Addendum 151 – UN Regulation No. 152

Revision 1 - Amendment 2

Supplement 2 to the 01 series of amendments – Date of entry into force: 30 September 2021

Uniform provisions concerning the approval of motor vehicles with regard to the Advanced Emergency Braking System (AEBS) for M₁ and N₁ vehicles

Figure 1

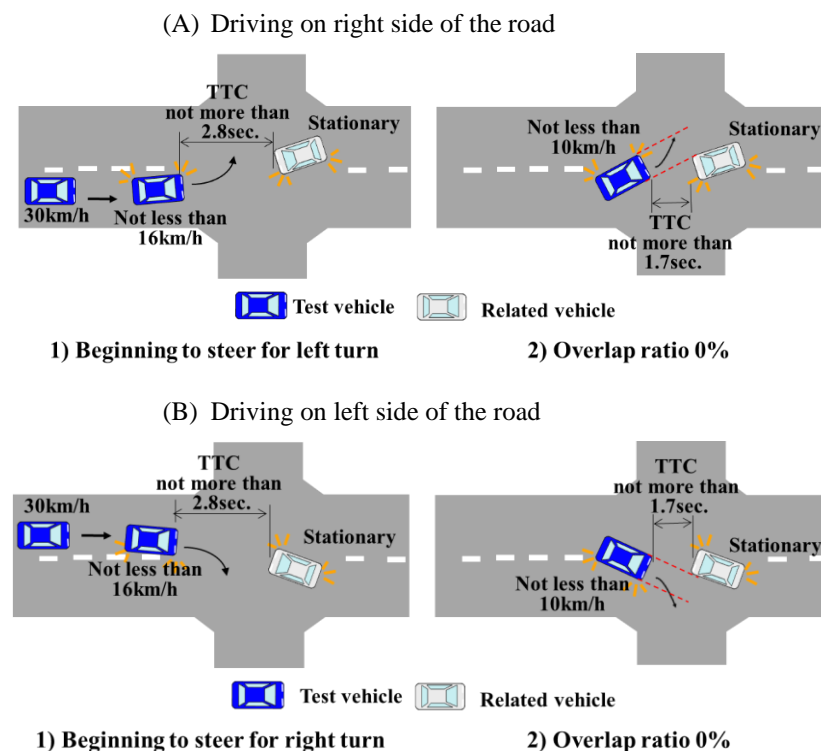
Insert new Scenarios 1 to 4, to read:

"Scenario 1

Left turn or Right turn at the intersection

- 1.1. In this scenario, the subject vehicle passes by a left turn or right turn in front of an oncoming vehicle that is stopped to make a left turn or right turn at an intersection.
- 1.2. An example of the detail scenario:

The subject vehicle drives at a speed of 30 km/h (with a tolerance of +0/-2 km/h) toward the intersection, and decelerates by braking to a speed of not less than 16 km/h at a point where the subject vehicle begins to steer left / right, and the Time To Collision (TTC) to the oncoming vehicle is not more than 2.8 seconds. When the subject vehicle turns left or right in the intersection, the speed is reduced to not less than 10 km/h, and then drives at a constant speed. The TTC to the oncoming vehicle is not more than 1.7 seconds at when the overlap ratio between the subject vehicle and the oncoming vehicle becomes 0 per cent.

Figure 2

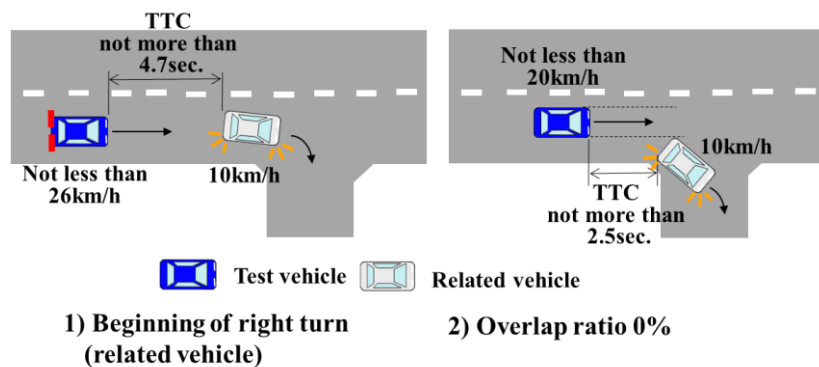
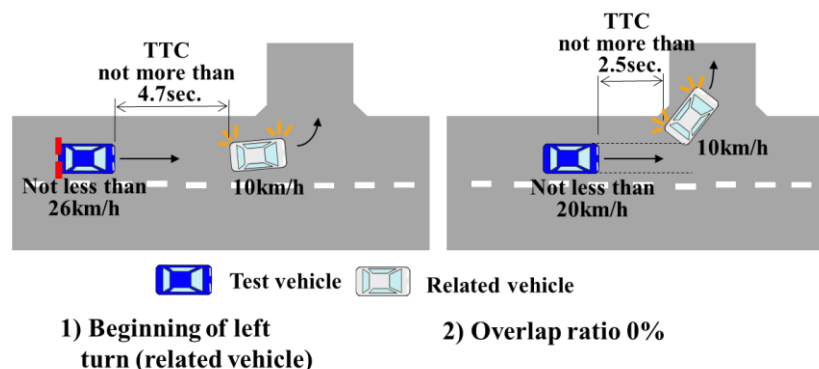
Scenario 2

Right turn or Left turn of a forward vehicle

- 2.1. In this scenario, the subject vehicle follows a forward vehicle. After that, the forward vehicle turns right or left at a corner, and the subject vehicle goes straight.

- 2.2. An example of the detail scenario:
- Both the forward vehicle and the subject vehicle drive at a speed of 40 km/h (with a tolerance of +0/-2 km/h) on the straight road. The forward vehicle decelerates by braking to a speed of 10 km/h (with a tolerance of +0/-2 km/h) in order to turn right or left at the corner, and the subject vehicle also decelerates by braking to keep appropriate distance with the forward vehicle. At when the forward vehicle begins to turn right or left, the speed of the subject vehicle is not less than 26 km/h and the TTC to the frontal vehicle is not more than 4.7 seconds. After that, the subject vehicle decelerates to a speed of not less than 20 km/h, and then drives at a constant speed. The TTC to the forward vehicle is not more than 2.5 seconds at when the overlap ratio between the subject vehicle and the forward vehicle becomes 0 per cent.

Figure 3

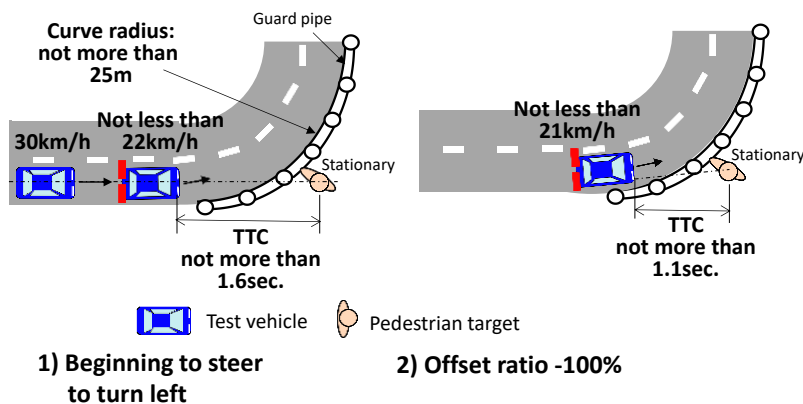
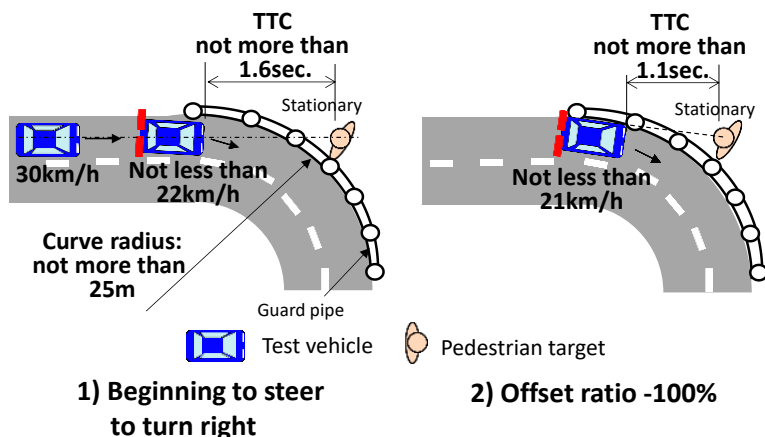
Scenario 3

Curved road with guard pipes and a stationary object

- 3.1. In this scenario, the subject vehicle drives a small radius curved road of which the guard pipes are constructed to the outer side, and a stationary vehicle (M₁ category), a stationary pedestrian target or a stationary bicycle target is positioned just outside of the guard pipes and where on the extension of the centre of the lane.

- 3.2. An example of the detail scenario:
- The subject vehicle drives at a speed of 30 (with a tolerance of +0/-2 km/h) km/h toward the curve of which the radius is not more than 25 m at the outer side of the road, and decelerates by braking to a speed of not less than 22 km/h at a point where the subject vehicle enters the curve. The TTC to the stationary object is not more than 1.6 seconds at when the subject vehicle begins to turn in the curve. In the curve, the subject vehicle drives outer lane than the centre of the road. After that, the subject vehicle continue to turn in the curve at a constant speed of not less than 21 km/h. The TTC to the stationary object is not more than 1.1 second at when the overlap ratio between the subject vehicle and the stationary vehicle becomes 0 per cent, or at when the offset ratio between the subject vehicle and the centre of the stationary pedestrian target or the stationary bicycle target becomes -100 per cent.

Figure 4

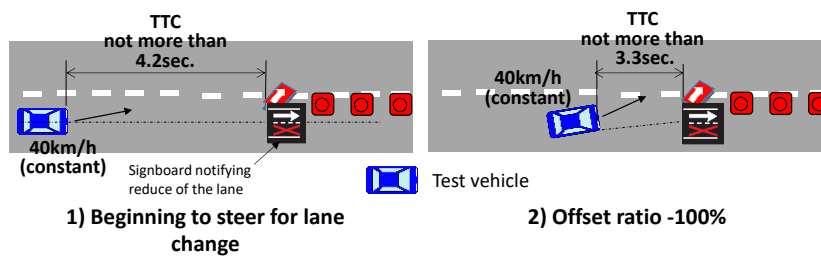
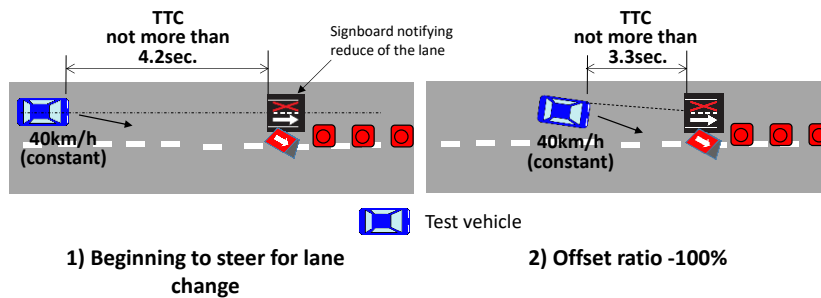
Scenario 4

Lane change due to road construction

4.1. In this scenario, the subject vehicle changes the lane in front of the signboard which is positioned in the centre of the lane and notifies the driver that the lane is reduced.

4.2. An example of the detail scenario:

The subject vehicle drives a straight road at a speed of 40 km/h (with a tolerance of +0/-2 km/h) and begins to steer in order to change the lane in front of the signboard which notifies reducing the lane. No other vehicles approach the subject vehicle. The TTC to the signboard is not more than 4.2 seconds at when the subject vehicle begins to steer. During changing the lane, the speed of the subject vehicle is constant, and the TTC to the signboard is not more than 3.3 seconds at when the offset ratio between the subject vehicle and the centre of the signboard becomes -100 per cent.
